To M. L. Ashby
From P. D. Despres
Date January 12, 1984
Subject REISSUE OF THERMAL RELIEF VALVE DISCHARGE CONTAINMENT DESIGN

To M. L. Ashby
From P. D. Despres
Date January 11, 1984
Subject Thermal Relief Valve Discharge Containment
Design No. 1983-400-1283-PDD
FINAL Design

Subject: TANK FARM VENT BLOWER (BL-412 A&B)
MODIFICATIONS
DESIGN NO. 204-400-884-VMF/SCR

FIGURE 1. RELIEF VALVE DISCHARGE CONTAINMENT SYSTEM

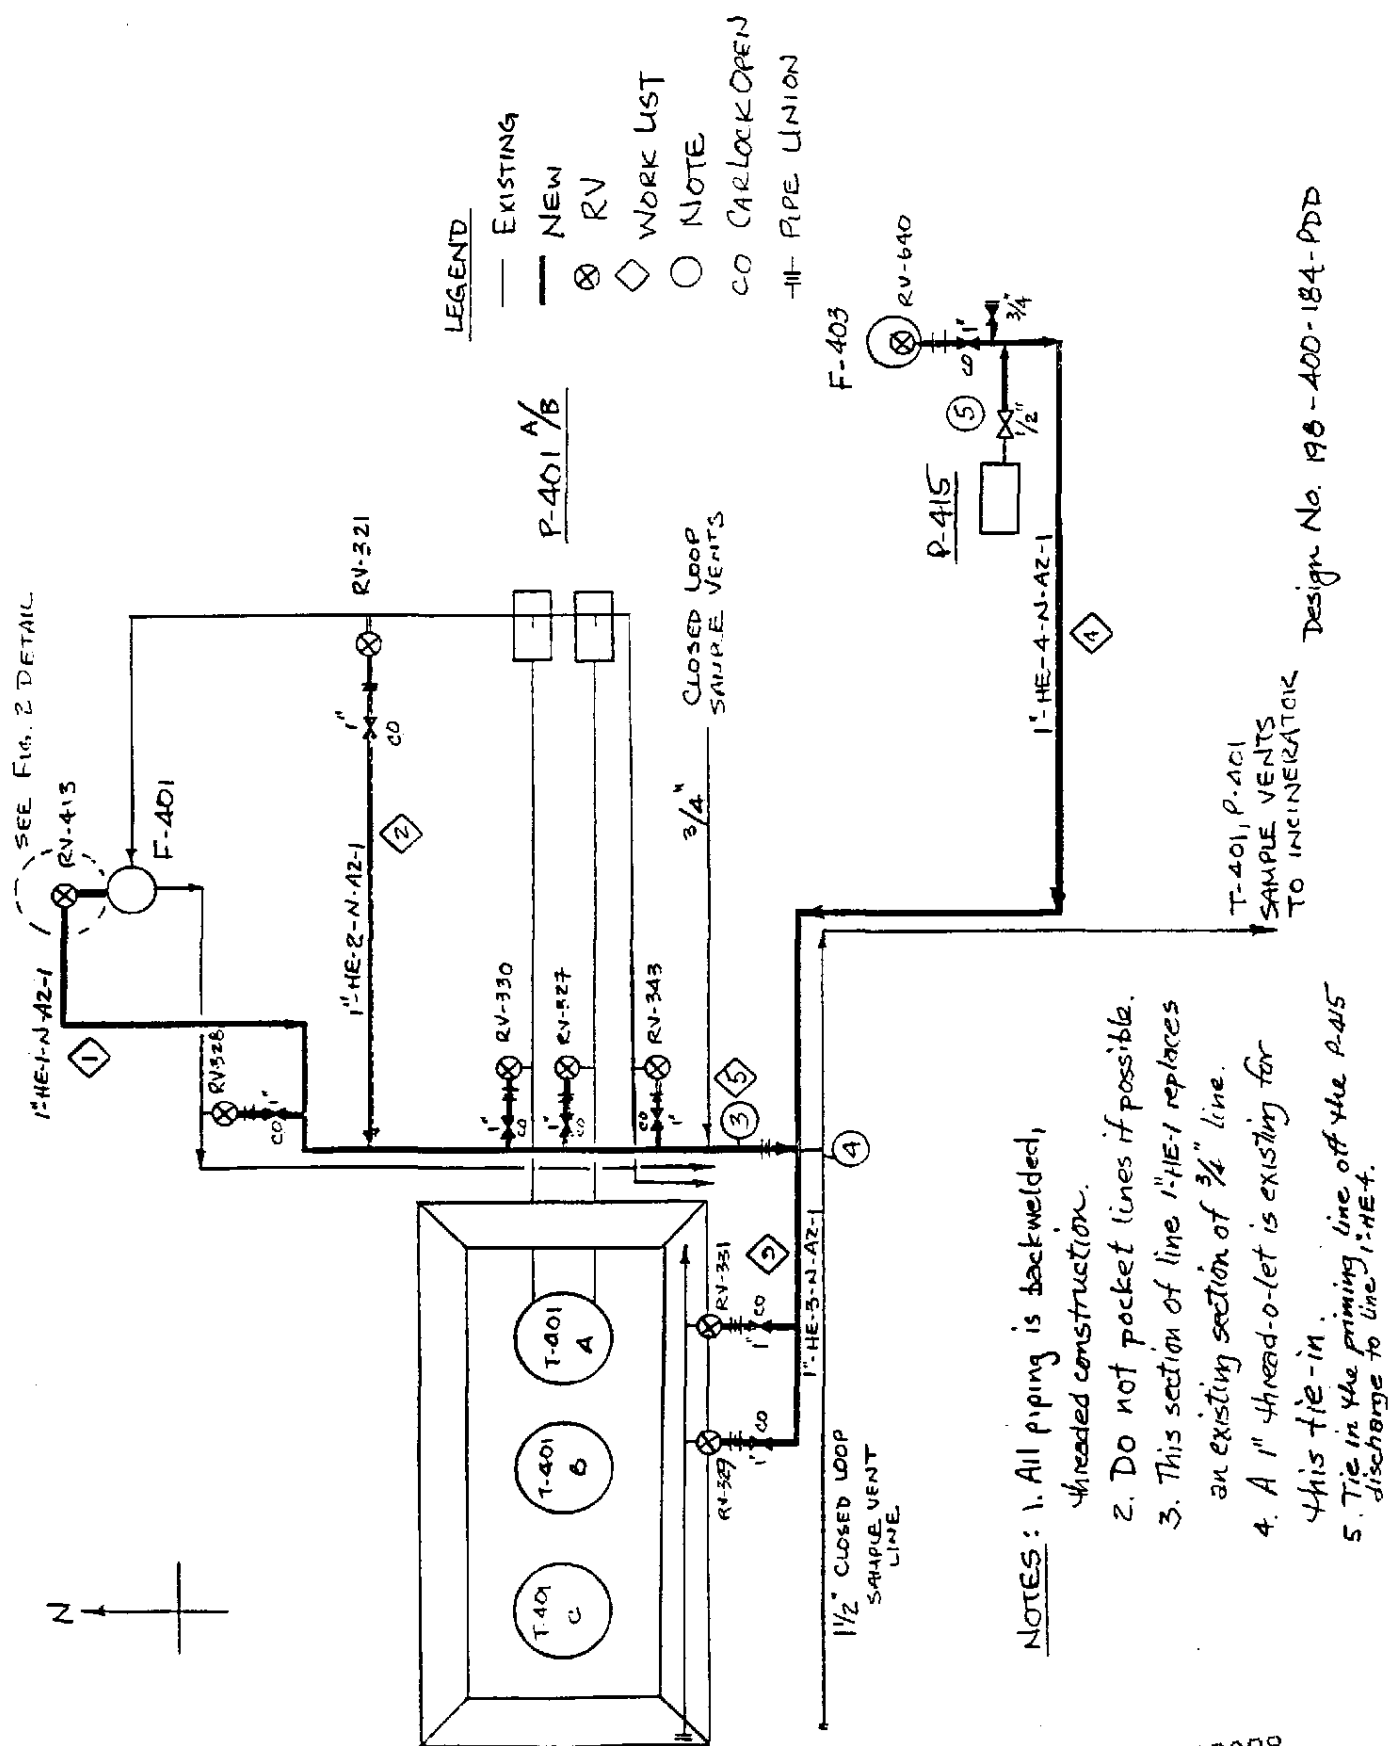
Figures 1 and 3 indicate the 2 areas in the tank farm where the 16 RVs are located. The valves themselves are listed in the attached Table 1 with their service descriptions and specifications. There will be two tie-in points to the vent line to the incinerator. The 9 valves indicated in Figure 1 will tie-in to the existing 1½" vent line now servicing the closed loop sampling system in the P-401 and T-401 area. The 7 RVs indicated in Figure 3 will be tied in to the existing ½" thread-o-let on the 3" railcar vent header in the pipe rack at the southwest corner of the T-411C dike. Thermal releases characteristically discharge very small quantities of vinyl chloride, so upsetting the incinerator will not be a problem with a direct tie-in to the vent header. The largest system will discharge less than 1 lb. of vinyl chloride due to thermal expansion at 30°C. Ten RVs on the vent recovery system now discharge directly to the incinerator vent line and have not caused a problem in the past.

Refer to Figure 1 for Items 1 through 4.

2. Run line 1"-HE-2-N-A2-1 from RV-321 and tie in to line 1"-HE-1. Install a pipe union and 1" block valve at the RV tie-in and backweld the threaded connections. Car seal open the valve.

3. Run line 1"-HE-3-N-A2-1 from RV-329 and PV-331 and tie in to line 1"-HE-1. Install a pipe union and 1" block valve at each RV tie-in and backweld the threaded connections. Car seal open the valves.

4. Run line 1"-HE-4-N-A2-1 from RV-640 on F-403 to line 1"-HE-1. Install a pipe union and 1" block valve at the RV and backweld all threaded connections. Car seal open the valve. Include a 3/4" bleed valve in the line by RV-640. Remove the existing 3/8" priming line from the P-415 discharge and run a ½" priming line from P-415 to line 1"-HE-4. Include a block valve in the line.

FIGURE 2. F-401 VCM FILTER RV PIPING

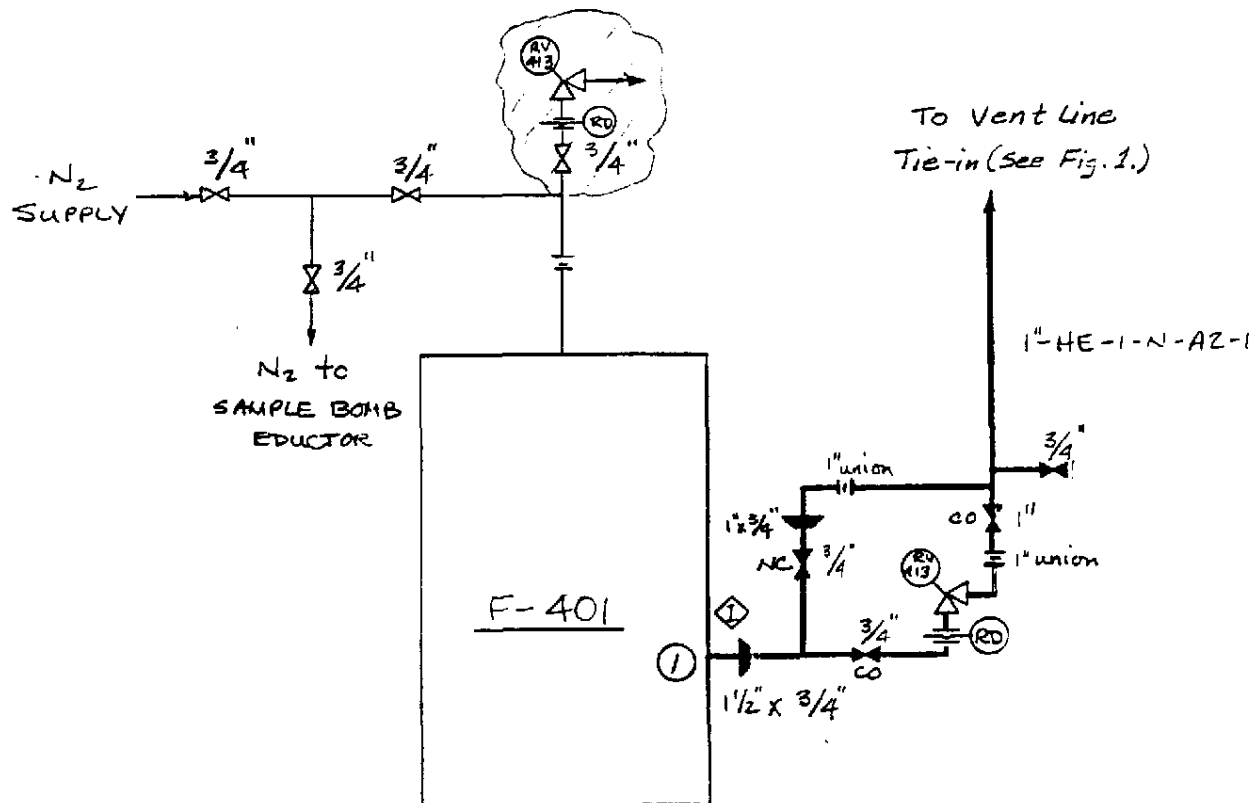
The original issue of the final design for RV discharge containment on January 11, 1984 contained two erroneous specifications Worklist item number 8 and note 1 in Figures 2 and 4 specified the removal of a segment of tubing between the nitrogen supply and the sample bomb eductors. This specification has been removed; the nitrogen is the motive fluid for the eductor, which is used to clear the sample lines when taking vinyl chloride samples. Please discard the old final issue and replace it with the attached.

The RVs on F-401 and F-402 (RV-413 and RV-414, respectively) will be re-located from the top head of the filter to the side to aid in clearing and changing the filters. A bypass line will be installed around the RVs to be used for clearing the dryers of vinyl chloride for opening. The vent line that presently ties back into the closed loop sampling vent from the N₂ supply line will be removed and the filters will be vented to the incinerator through the RV bypass (see Figures 2 and 4).

1. Relocate RV-413 to the 1½" connection on the side of F-401 (see Figure 2). Run line 1"-HE-1-N-A2-1 from RV-413 on F-401 and RV-328 to the 1" tee in the 1½" vent line for the closed loop sampling system. A section of the existing 3/4" closed loop sampling vent line will be removed and the remaining section tied back into line 1"-HE-1 (see Note 3, Figure 1). Tie in RVs -330, -327, -343 to line 1"-HE-1. Include a 1" block valve and pipe union at each RV. At F-401, include a 1½" x 3/4" concentric reducer and a 3/4" block valve between the filter and RV-413, and a 1" pipe union and 1" block valve downstream of the RV (refer to Figure 2). Include a bypass around RV-413 with a 3/4" block valve, concentric 1" x 3/4" reducer and a 1" pipe union. Include a 3/4" bleeder in the line and backweld all threaded connections.

FIGURE 3. RELIEF VALVE DISCHARGE CONTAINMENT SYSTEM

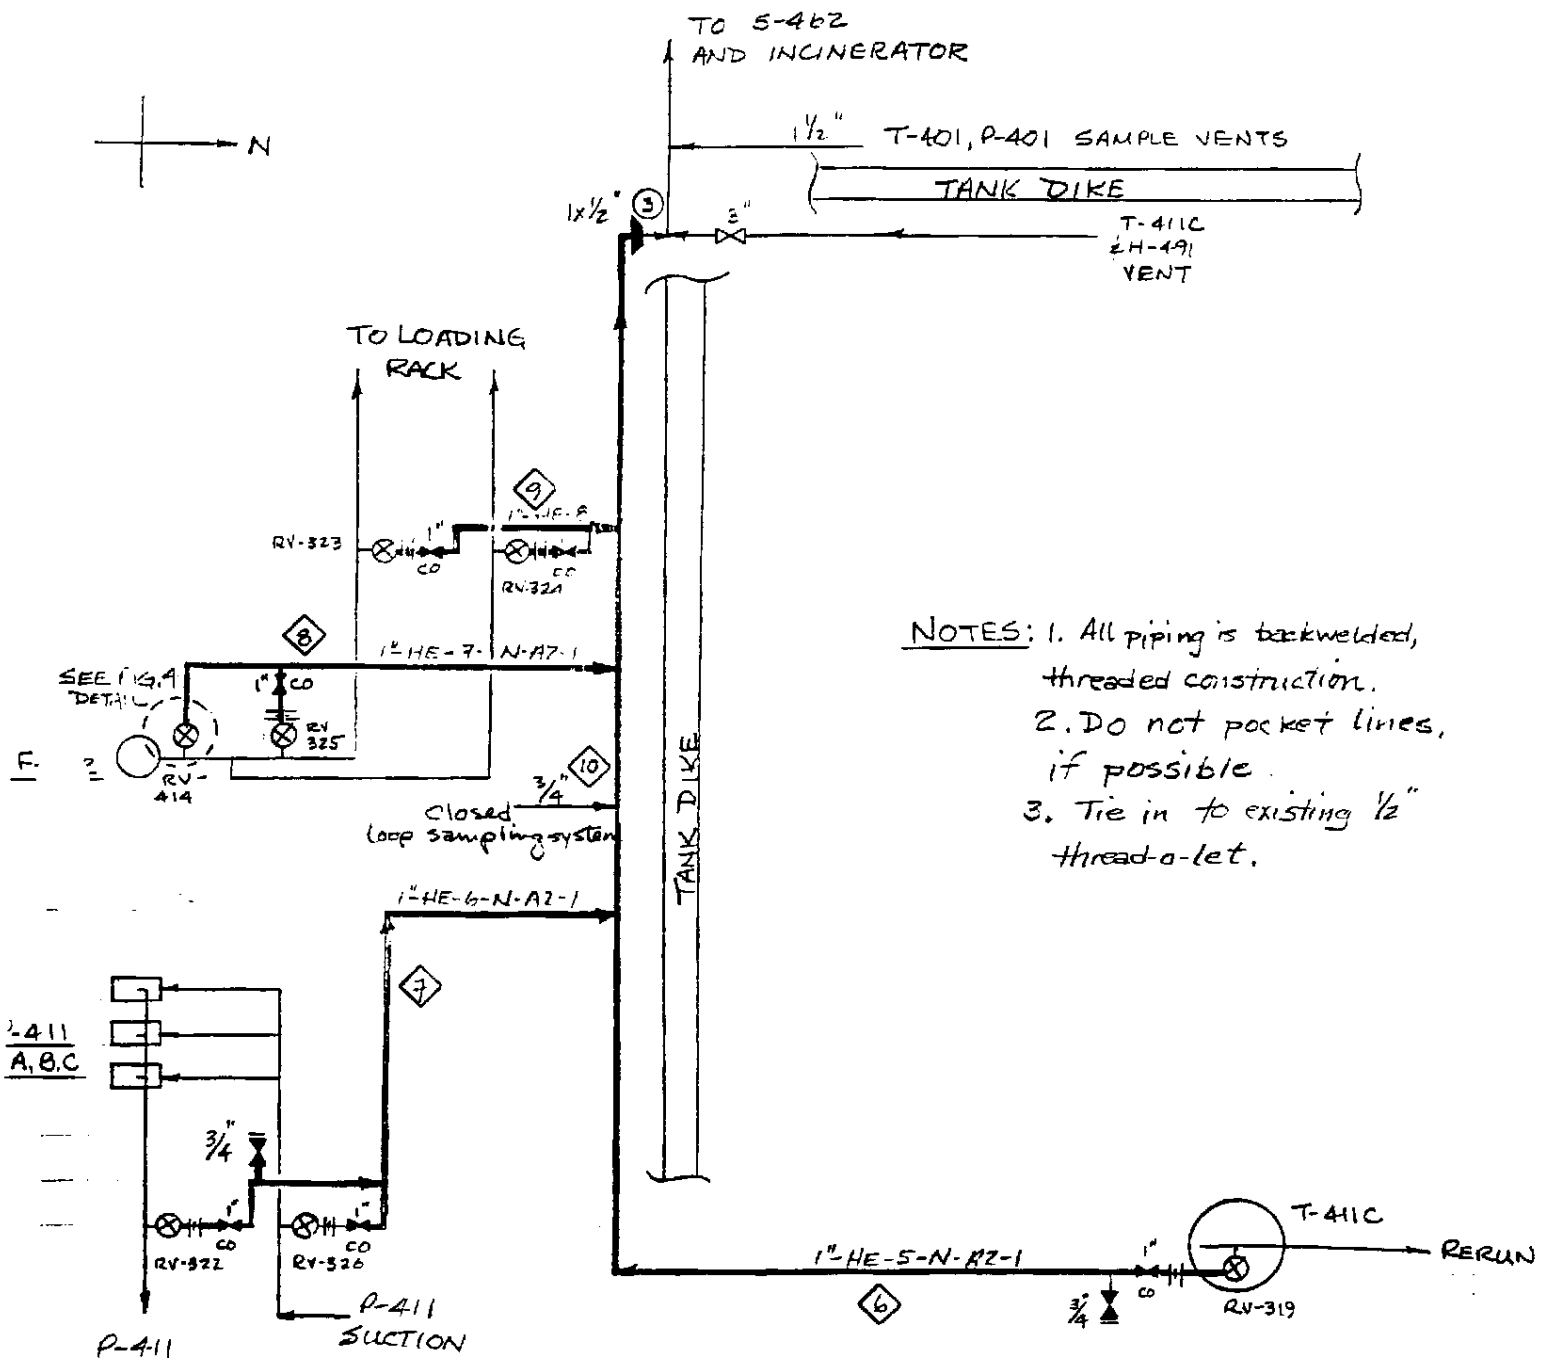
Refer to the attached Figure 3 for Items 6 through 10.

6. Run line 1"-HE-5-N-A2-1 from RV-319 on the rework line under T-411C to the ½" thread-o-let on the 3" vent line from T-411C at the SW corner of the tank dike. Install a pipe union and 1" block valve at the RV tie-in and backweld all threaded fittings. Car seal the valve open. Include 1 3/4" bleed valve by the RV and a 1 x ½" concentric reducer at the thread-o-let.
7. Run line 1"-HE-6-N-A2-1 from RV-322 on the P-411 discharge header and RV-326 on the suction header and tie in to line 1"-HE-5. Install unions and 1" block valves at the RV tie-ins and backweld all threaded connections. Car seal the valves open. Include a 3/4" bleed valve by RV-322.

FIGURE 4. F-402 VCM FILTER RV PIPING

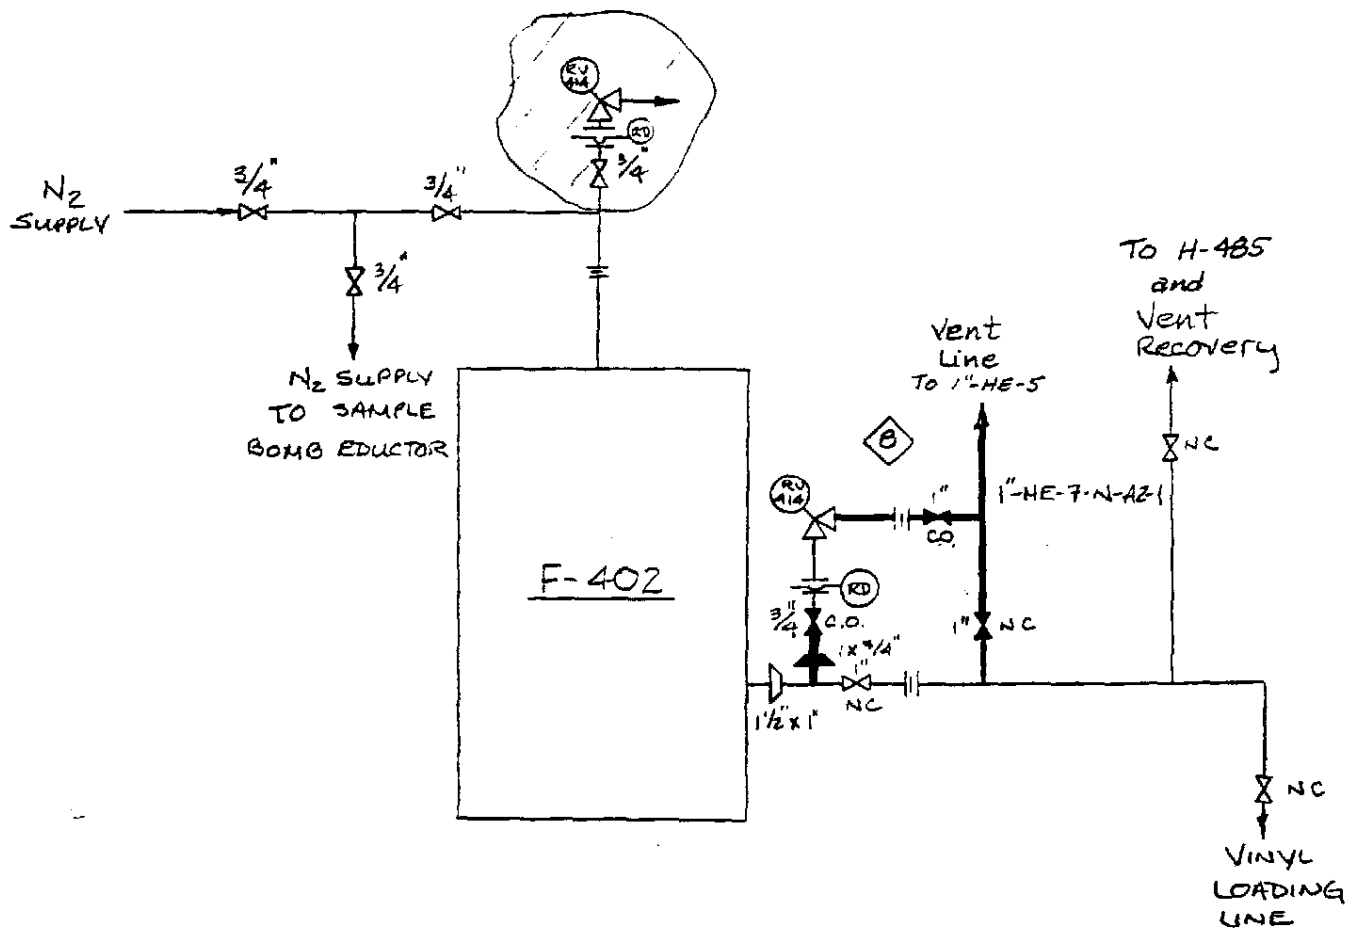
8. Run line 1"-HE-7-N-A2-1 from RV-414 and RV-325 on F-402 and F-402 outlet line and tie in to line 1"-HE-5. Include a 1" pipe union and block valve on RV-325. Relocate RV-414 to the 1" vent line on the side of F-402 (refer to Figure 4). Include a 1 x 3/4" concentric reducer and block valve upstream of the RV and a 1" pipe union and block valve downstream. Car seal open the valves. Include a 1" bypass valve around the RV. Backweld all threaded connections.
9. Run line 1"-HE-8-N-A2-1 from RVs -323 and -324 and tie in to line 1"-HE-5. Include 1" pipe unions and block valves at the RV tie-ins and backweld the threaded connections. Car seal open the valves.
10. Tie in the 3/4" closed loop sampling system vent line to line 1"-HE-5-N-A2-1.
